From: "Dave Lochbaum" <dlochbaum@ucsusa.org>
To: "Dave Lochbaum" <dlochbaum@ucsusa.org>
Date: 5/4/04 2:04PM
Subject: BWR Containment Overpressure

Paul Blanch, during his review of the proposed power uprate at Vermont Yankee, discovered that Entergy wants to take credit for containment overpressure following an accident. As described in the attached backgrounder we developed, the NRC has long barred this safety compromise.

BWR Containment Overpressure

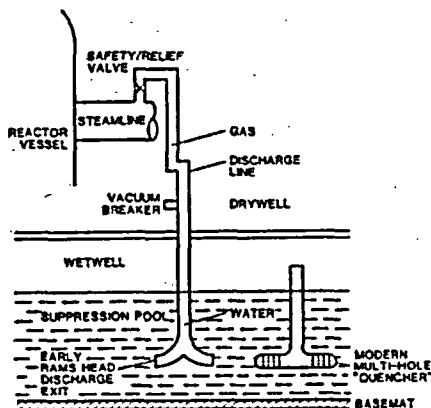
Some nuclear plant owners, like that for Vermont Yankee, seek to take credit for containment overpressure in order to meet the NPSH requirements for the ECCS pumps at uprated power levels. Containment overpressure is the pressure above atmospheric inside the containment caused by the energy released during the accident. That pressure, when added to the static head, can keep the water pressure inside the pump from dropping below the vapor pressure, avoiding the situation shown in the lower curve in the graphic. The plants were originally built and licensed for static head alone to keep pressure above the vapor pressure. But higher suppression pool water temperature and/or higher ECCS pump flow rates at power uprate levels drop the pressure below the vapor pressure – unless containment overpressure is available.

However, there are several reasons why the containment overpressure may not be available. The accident scenario outlined above involves a pipe breaking inside containment. The energy released from that broken pipe pressurizes the drywell first and very quickly thereafter heats up the suppression pool water. Assuming no other complications, containment overpressure is virtually guaranteed because its arrival precedes that of the warmed suppression pool water.

Rather than take credit for containment overpressure and hope that one of these possible scenarios doesn't occur, the NRC should protect the public by insisting that adequate NSPH for ECCS pumps be guaranteed by static head alone. Anything less means that public protection standards are being sacrificed at the corporate profit altar. Greed is insufficient reason to abandon this long-time safety principle.

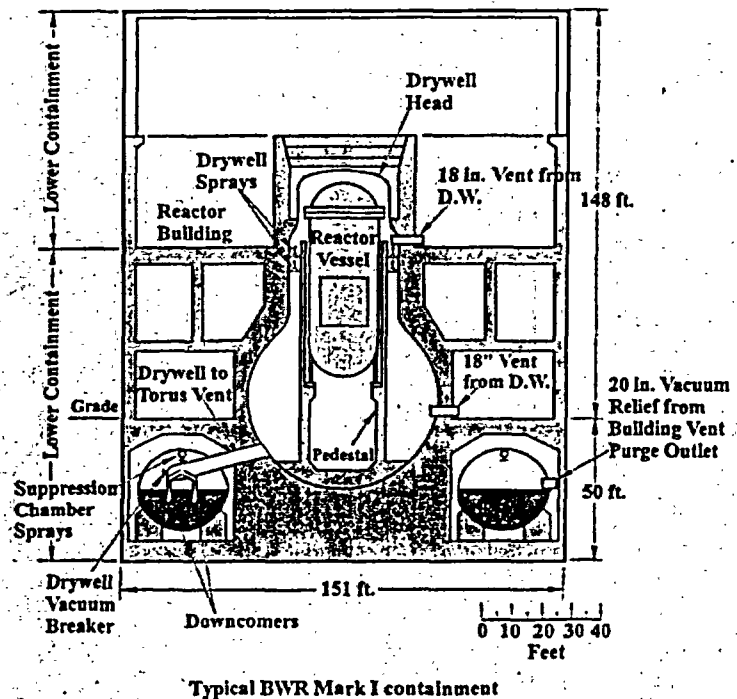
Another possible accident scenario where containment overpressure might not be available involves the containment spray system. Two carwash-styled piping rings, labeled Drywell Sprays, are shown in the cross-section view of a Mark I containment like the one at Vermont Yankee. The containment spray system sends water out through nozzles in these piping rings to cool down the sauna-like conditions inside the drywell following an accident. The containment spray also tends to cool down the suppression pool water. But anyone who has spent a day at the beach and experienced the air temperature swing from cool to hot to cool while the ocean temperature stays constant can appreciate that the suppression pool temperature is slow to change after containment spray initiation. Thus, if the containment spray is inadvertently initiated, whether caused by equipment failure or operator error, the containment overpressure condition may suddenly end.
